HATTERAS

HATTERAS REVISION LIST - STRUCTURAL:

HATTERAS REVISION LIST - ARCHITECTURAL:

DREAM FINDERS HOMES HATTERAS

SLAB INTERFACE PLAN

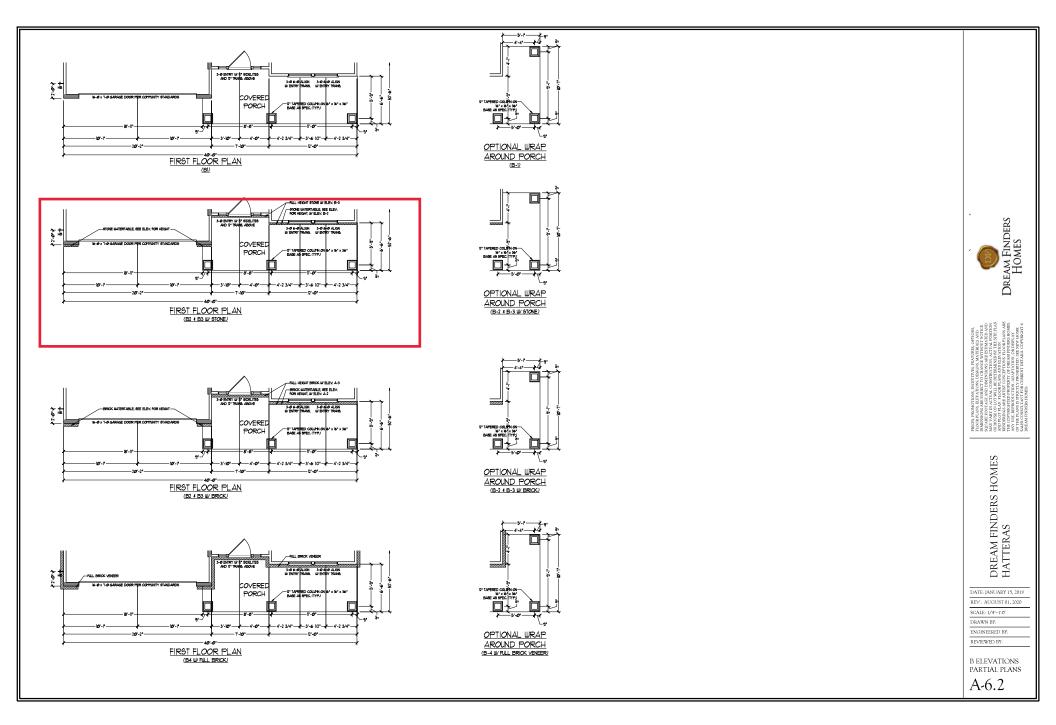
- 25. VERIFIED ROOM SIZES
 - ADDED SLAB INTERFACE SHEET (SEE A-4)
- ADDED CONDUIT LINE IN KITCHEN
- 28. NOTED PENDANT LIGHTS IN KITCHEN AS "OPTIONAL PENDANTS"

WALL SECTIONS AND STAIR DETAIL

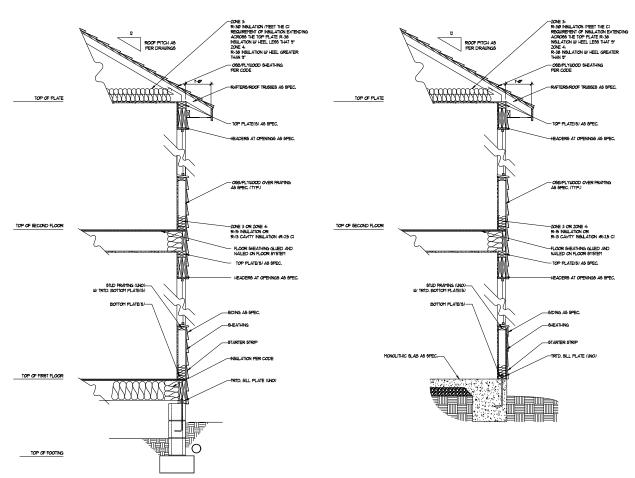
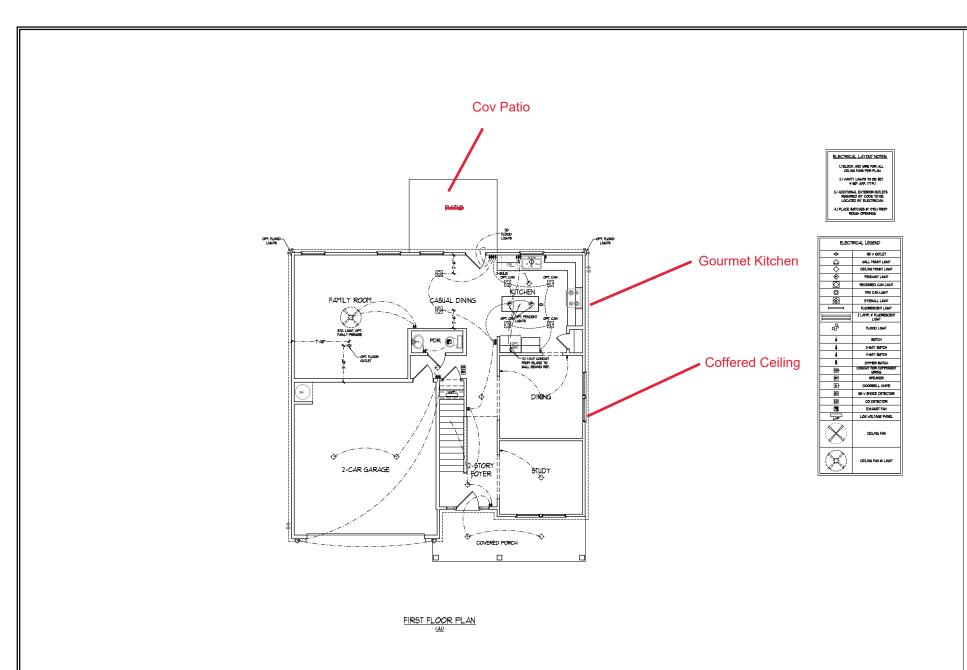
- ADDED INSULATION DETAIL (SEE AD-1)
- ADDED OPTIONAL GOURMET KITCHEN
- REMOVED FLOOR HATCHING
- 20. REMOVED STAIR NUMBERS
- 21. REMOVED VAULTS FROM BEDROOMS
